**NEW SPENCER MIDDLE SCHOOL**

**ADDENDUM #6**

**July 20, 2022**

**THRASHER PROJECT #060-10259**

**1 ENLARGED FIRST FLOOR PLAN AREA A**  
A1.02 1/8" = 1'-0"

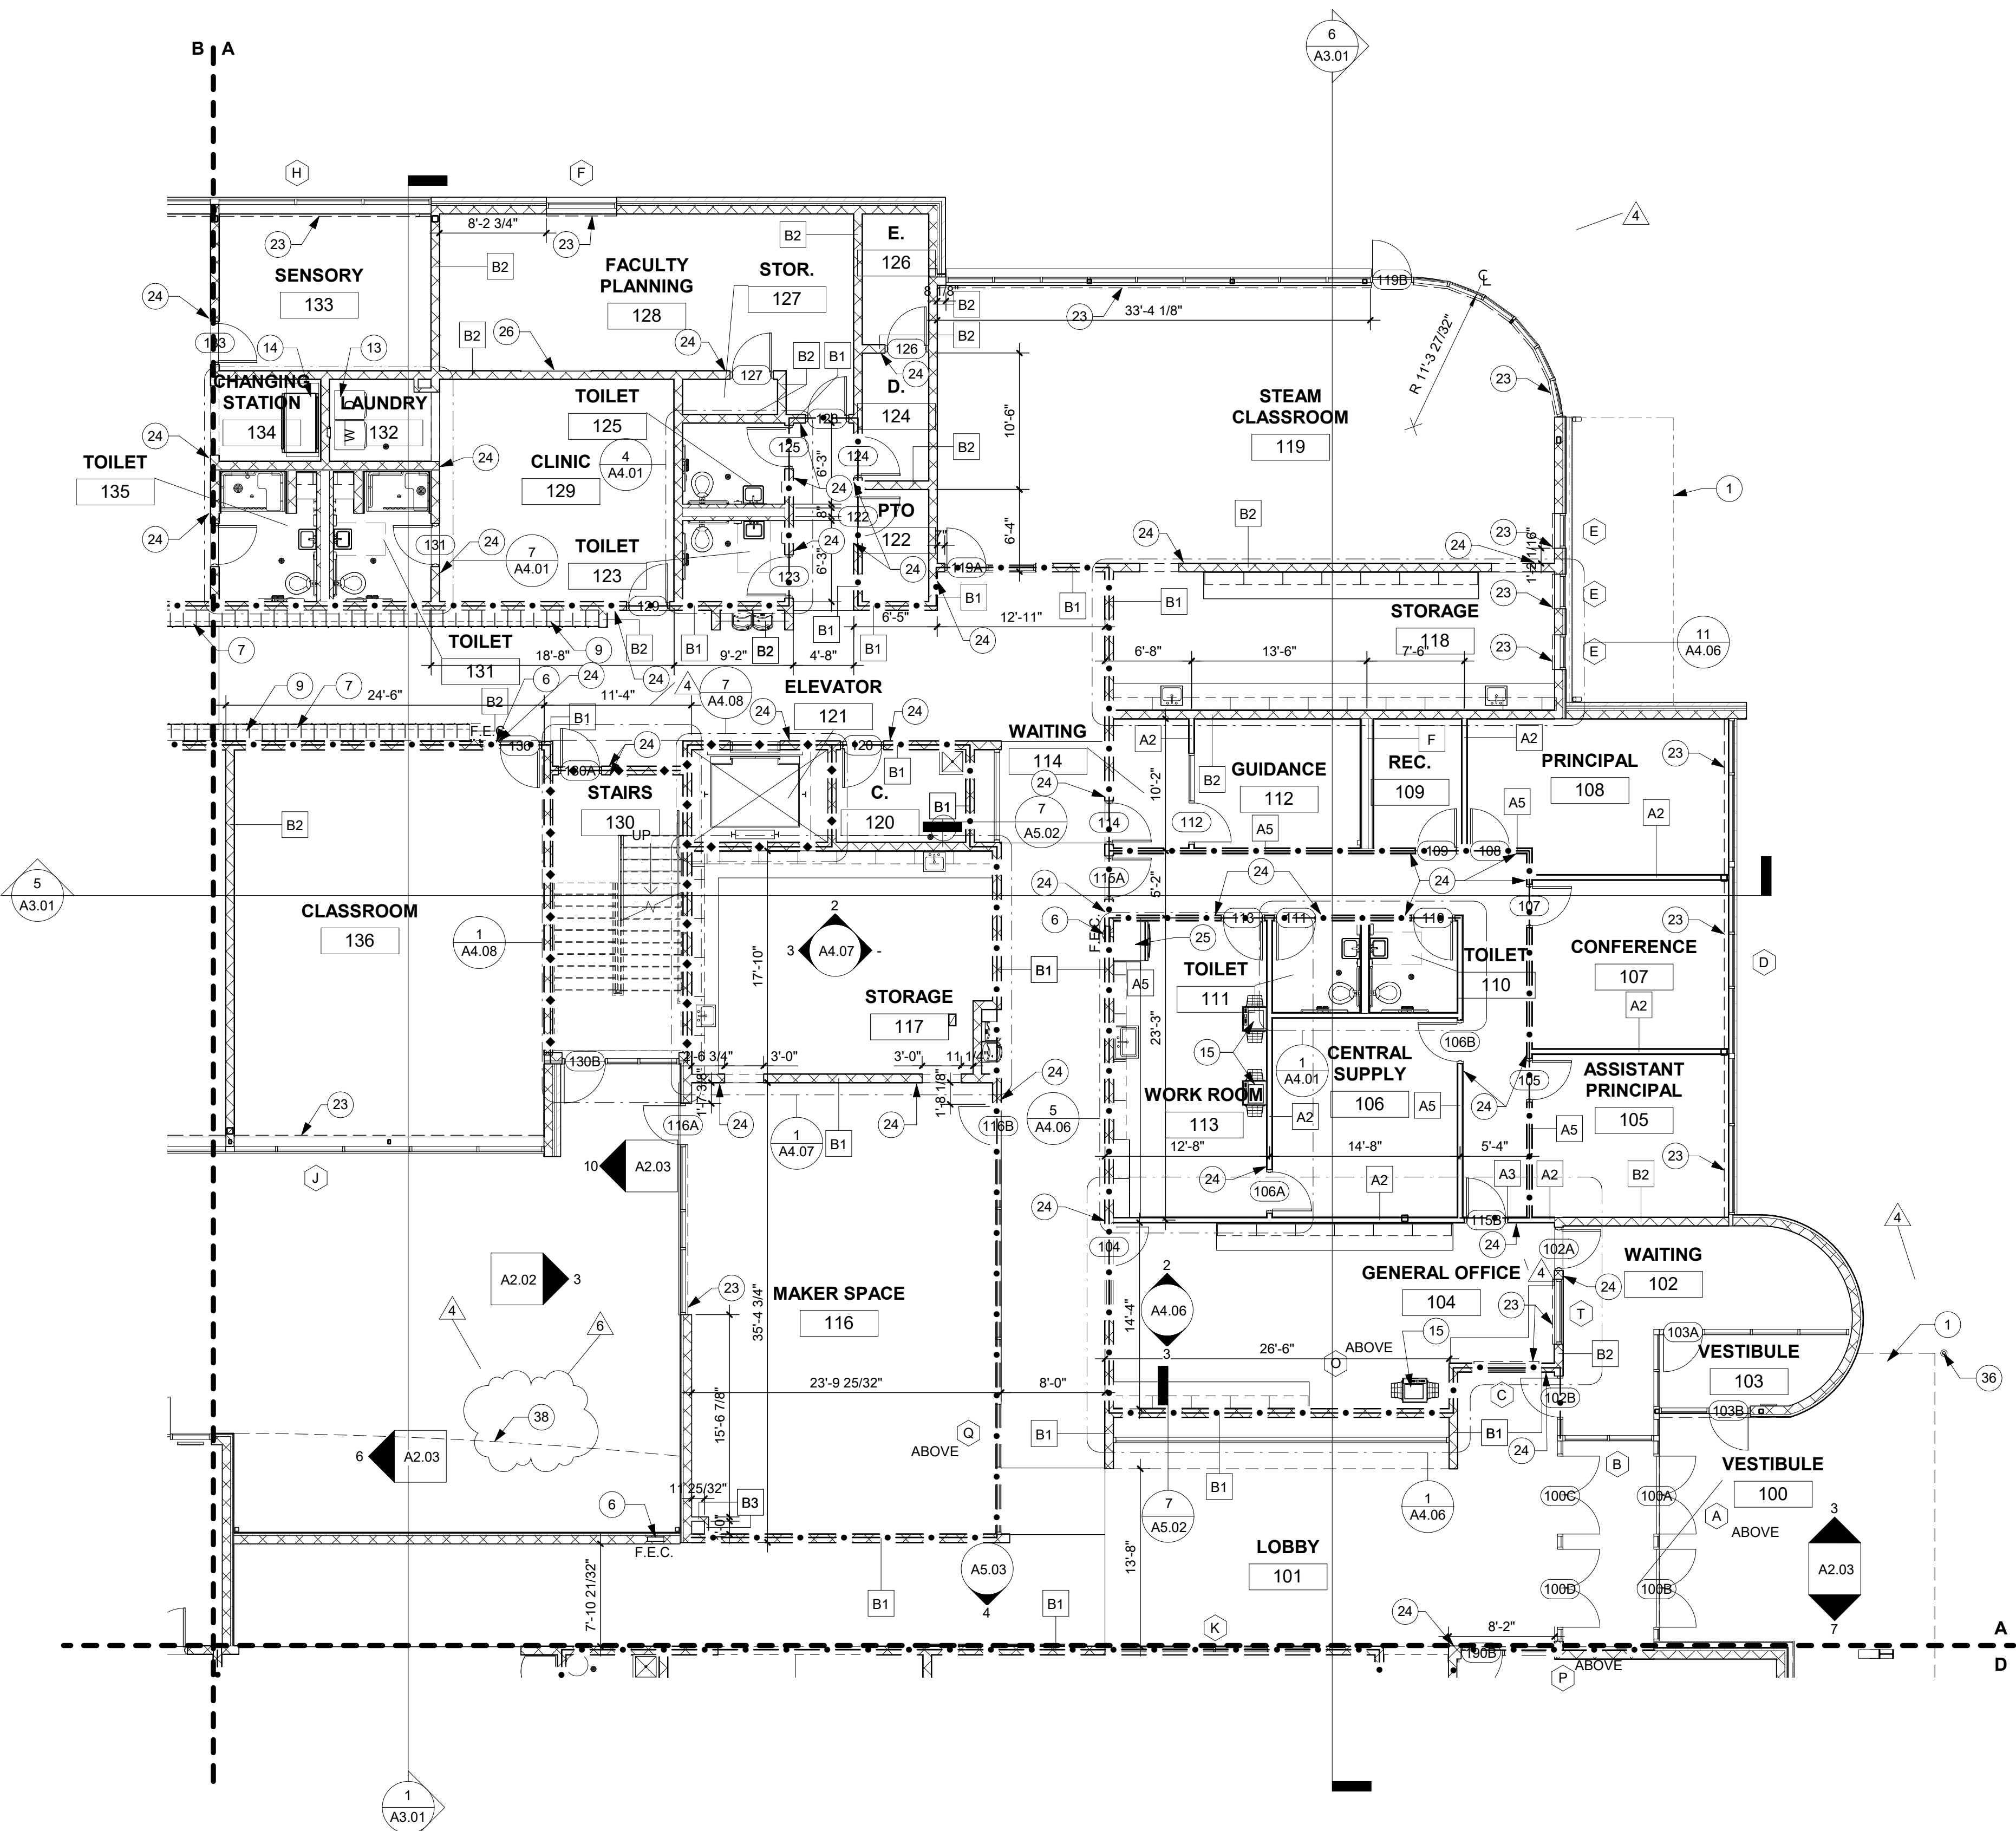
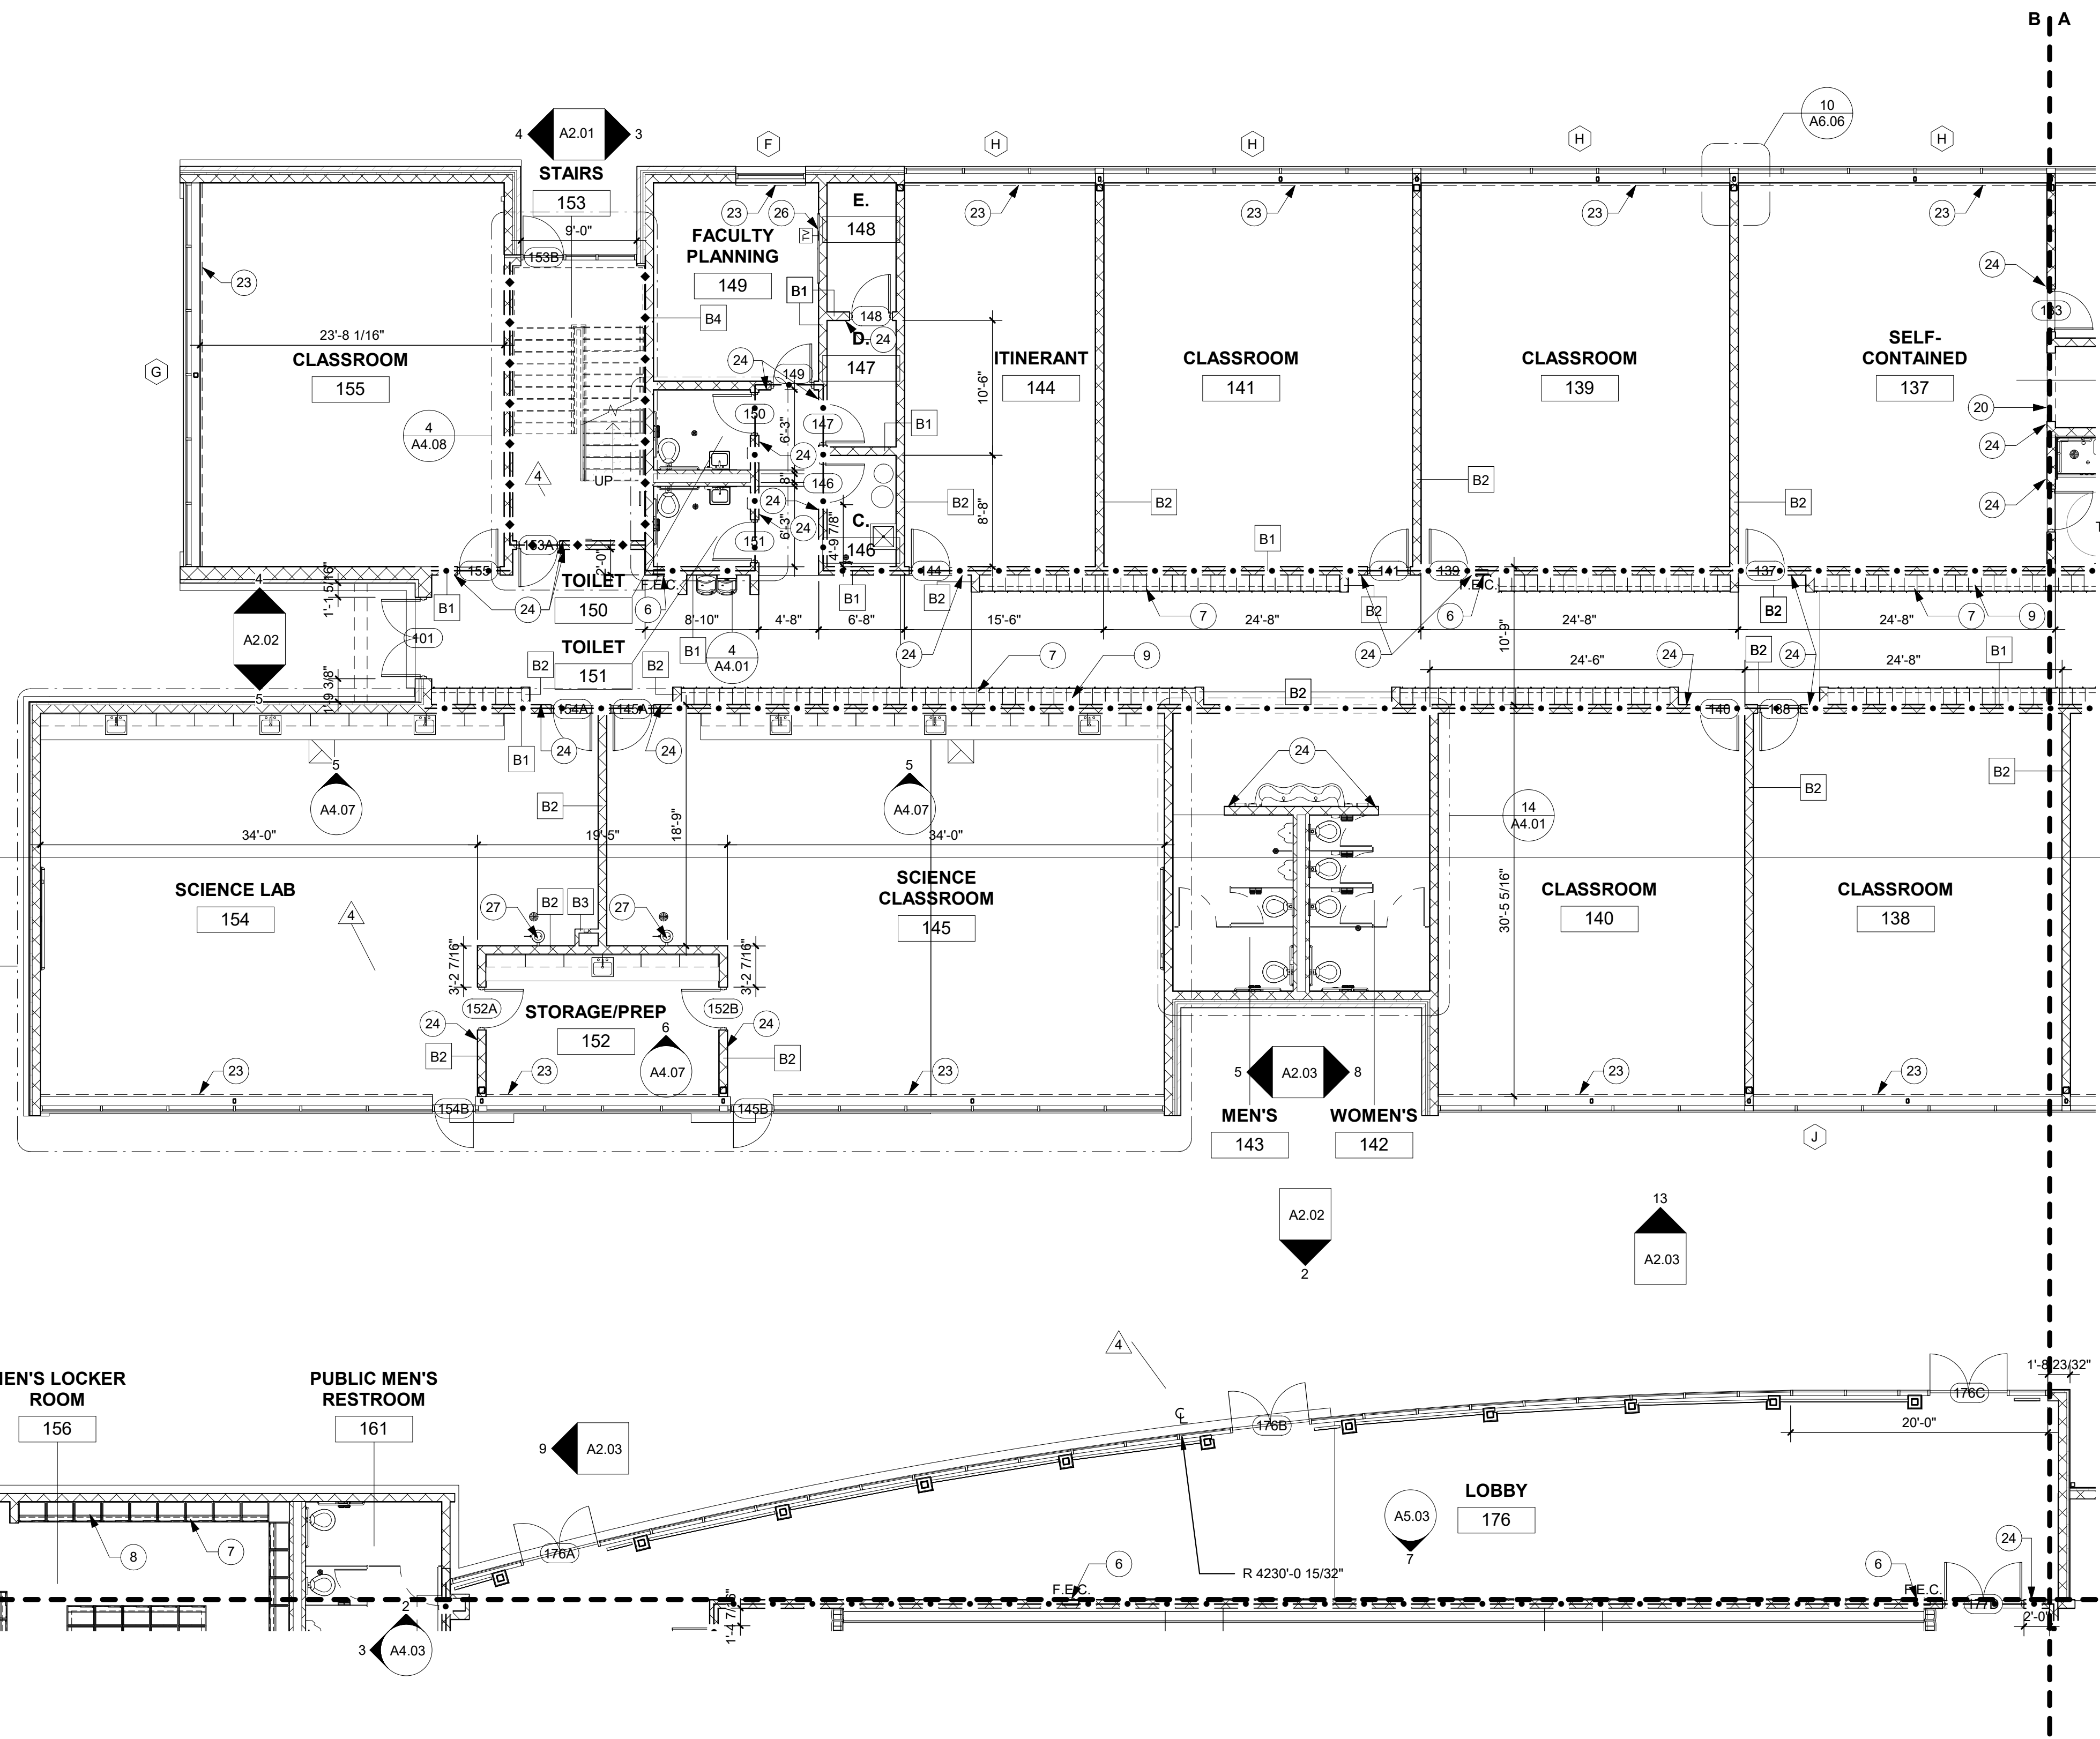
17. Addendum 4, Drawings A1.01-A1.05 revised Keynote 23 to “Line of premanufactured awnings” Keynote 23 was “Shades” and is noted at many windows and storefronts. Please clarify.

Drawing revised in this addendum.
